Access Compliance Report

Public Rights-of-Way

(Curb Ramps)

Intersection ID: 12850	Main Street: CONNELLY_CR	Cross Street: MORRIS_FIELD_DR	Location: NW
ADA ID: E703C56B3253	Ramp Type: Directional1	Initial Pass/Fail: Fail	Overall Compliance: No
Severity Score: 1.25			
Codes/Mitigation Info/Possible Solution		Field Measurements/Component Compliance

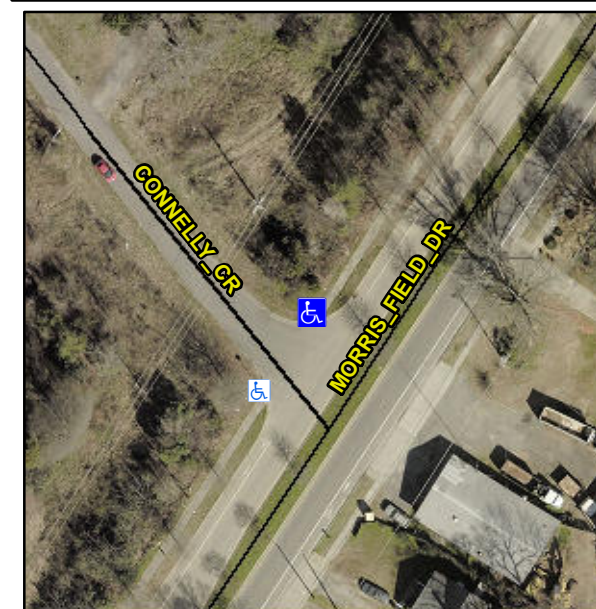
PROW/ADA:

R304.5.3

Compliance	Description	Data	Compliance	Description	Data
N/A	Ramp Length (in)	34.0	N/A	Grade Break?	N/A
Yes	Ramp Width (in)	60.0	N/A	Grade Break Slope (%)	0.0
Yes	Ramp Slope (%)	5.5	N/A	Grade Break XSlope (%)	0.0
No	Ramp XSlope (%)	2.6			
N/A	Flare Type LT	N/A	N/A	Flare Type RT	N/A
N/A	Flare Slope LT (%)	N/A	N/A	Flare Slope RT (%)	0.0
N/A	Flare Traversable LT?	N/A	N/A	Flare Traversable RT?	N/A
N/A	Landing Length (in)	0.0	N/A	DWS Provided?	N/A
N/A	Landing Width (in)	0.0	N/A	DWS Contrast?	N/A
N/A	Landing Slope (%)	0.0	N/A	DWS Length (in)	N/A
N/A	Landing X Slope (%)	0.0	N/A	DWS Full Width?	N/A
N/A	Landing Curb? (Y/N)	N/A	N/A	DWS Offset LT (in)	N/A
N/A	Shared Landing?	N/A	N/A	DWS Offset RT (in)	N/A
N/A	Gutter Ponding?	0.0	N/A	Gutter Slope (%)	N/A
N/A	Gutter Lip Ht (in)	0.0	N/A	Gutter X Slope (%)	N/A
N/A	Painted X Walk1?	No		Road Slope (%)	2.2
	X Walk 1 Direction	To S		Road X Slope (%)	9.0
	X Walk 1 Width (in)	N/A		Clear Space?	N/A

X Walk 1 Slope (%)	2.2	N/A	Clear Space to XWalk (in)	N/A
	X Walk 1 X Slope (%)	9.0	N/A	Storm Grate/Utility Hazard?	N/A
N/A	Ramp inside XWalk1?	N/A		Storm Grate/Utility Type	
N/A	Any Obstructions?	N/A			N/A
	Obstruction Type		Yes	Surface Condition? (G/P)	Good
			N/A	Curb Slope (%)	3.0

Possible Solutions:

Remove & Replace Entire Ramp.
